Item 1 – Sage Meadow Estates Phase 1 Final Subdivision Plat

Project: DEV-11030 | Sage Meadow Estates

**Wasatch County
DESIGN REVIEW
COMMITTEE (DRC)
COMMENTS**

PROJECT ID: DEV-11030
PROJECT NAME: FINAL SUB - SAGE MEADOW ESTATES -
PHASE 1
VESTING DATE: 11/7/2025
REVIEW CYCLE #: 3

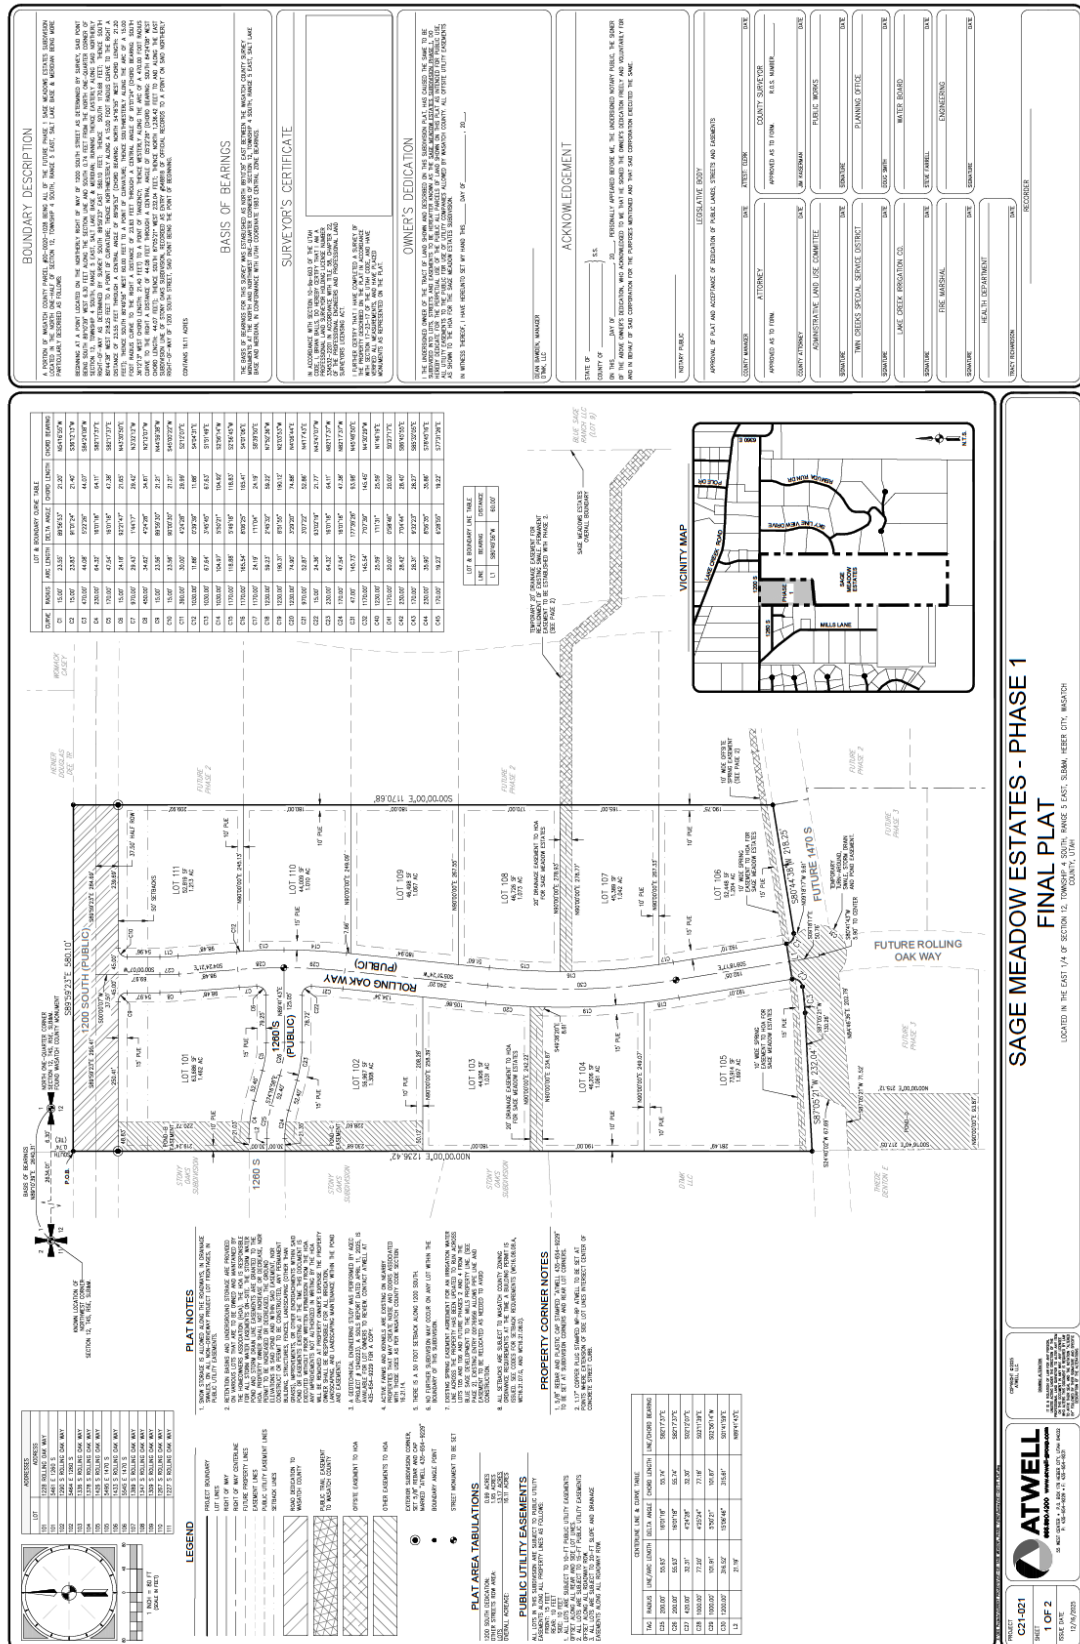
DRC - GIS Dept		
Comment ID	Sheet Name	Comment
DRC-GIS2	02a - Plat	Conditional approval: Typo in address table. Please add directional "S" on "1228 S ROLLING OAK WAY".

DRC - Recorder Office		
Comment ID	Sheet Name	Comment
DRC-REC1	02a - Plat	addresses will need to be assigned before recording.

DRC - Surveyor Office		
Comment ID	Sheet Name	Comment
DRC-SUR1	02a - Plat	# 1 The survey you submitted is not on file as a Record of Survey, please file such. # 2 You call out the NW corner of Section 12 as obliterated ad our field crew tells us the monument is in place. # 3 Your curve / line table is incomplete.

# 4 The right of way on 12th South is large enough to fit your called fro 37.5 feet 1/2 road. As you pave, please match the projects to either side.
--	--	--

EXT – MAG Regional Trail Planner		
Comment ID	Sheet Name	Comment
DRC-MAG1	02a - Plat	Conditional approval. An 8' improved pedestrian trail with a 20' easement is required along 1200 S.

Exhibit E – Fencing Plan

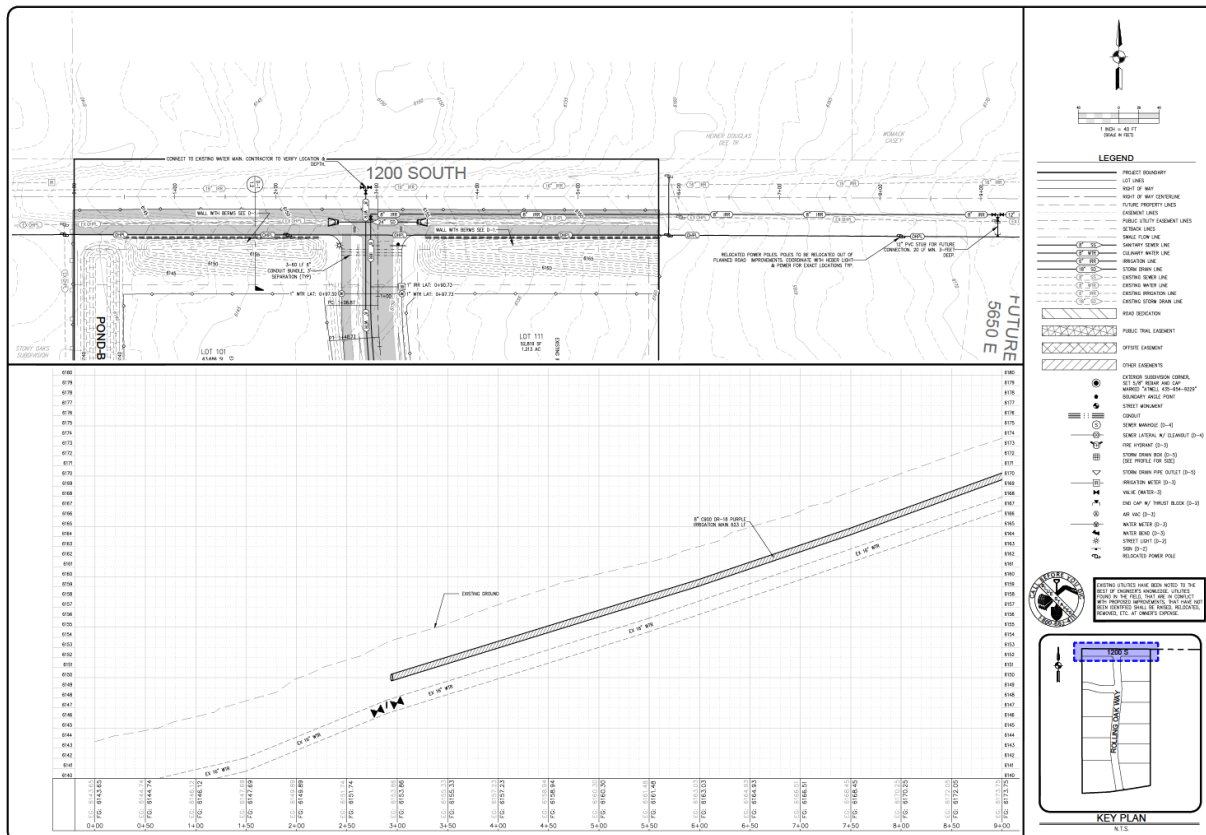
The application has provided a fencing plan that shows the existing fences that will remain in place along the South of the subject property. New fencing is proposed along the West subdivision boundary (See Exhibit F). The plans also include a detail image for the fence showing that it is proposed to be four feet in height and composed of wire mesh with barbed wire at the top and bottom.

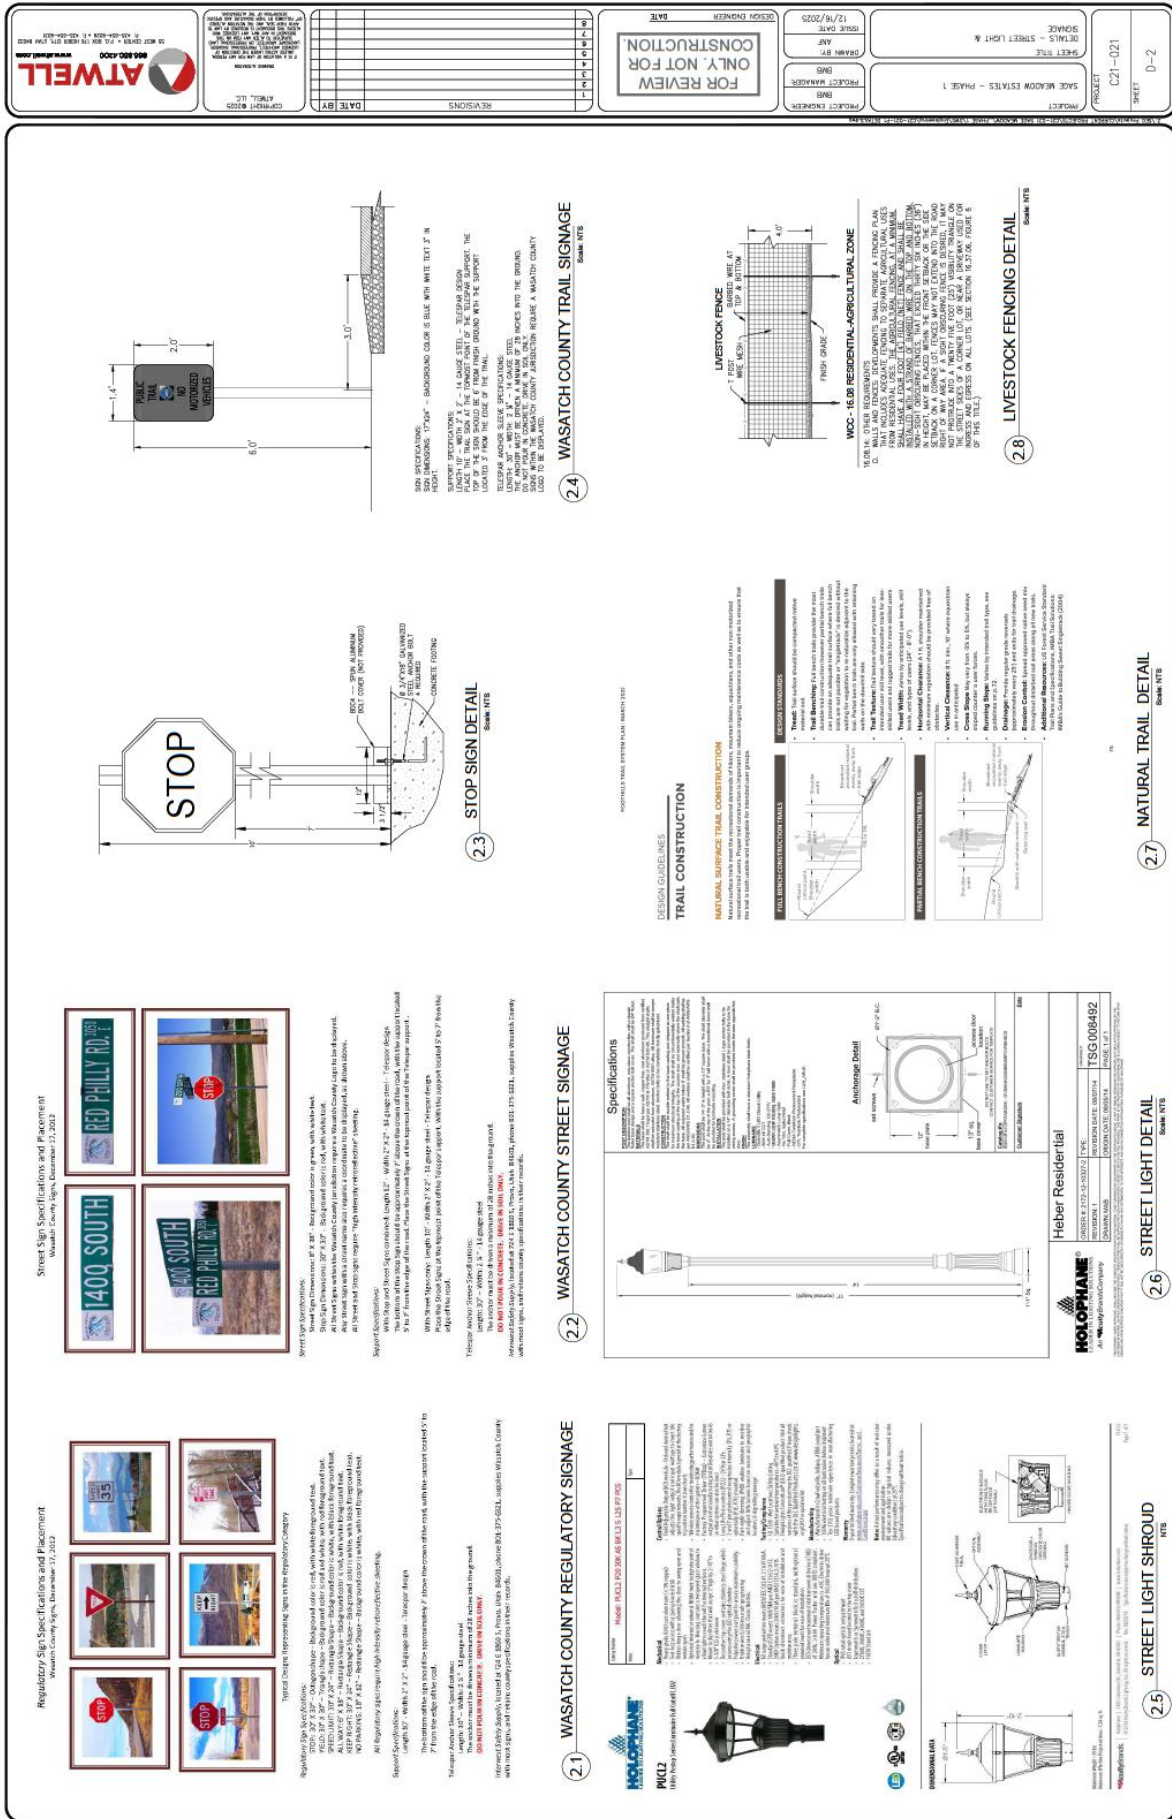
DRC - Engineering Dept		
Comment ID	Sheet Name	Comment
DRC-ENG8	11 - Lighting and Signage Plan	Note: Per updated code, street lights are only needed at the intersection of 1200 South.

DRC - Public Works Dept		
Comment ID	Sheet Name	Comment
DRC-PW1	10 - Street Plan	This sheet should show power pole relocation
DRC-PW2	11 - Lighting and Signage Plan	Recent code change now only requires street lights to be located on intersections with collectors and arterials. Please, adjust accordingly.
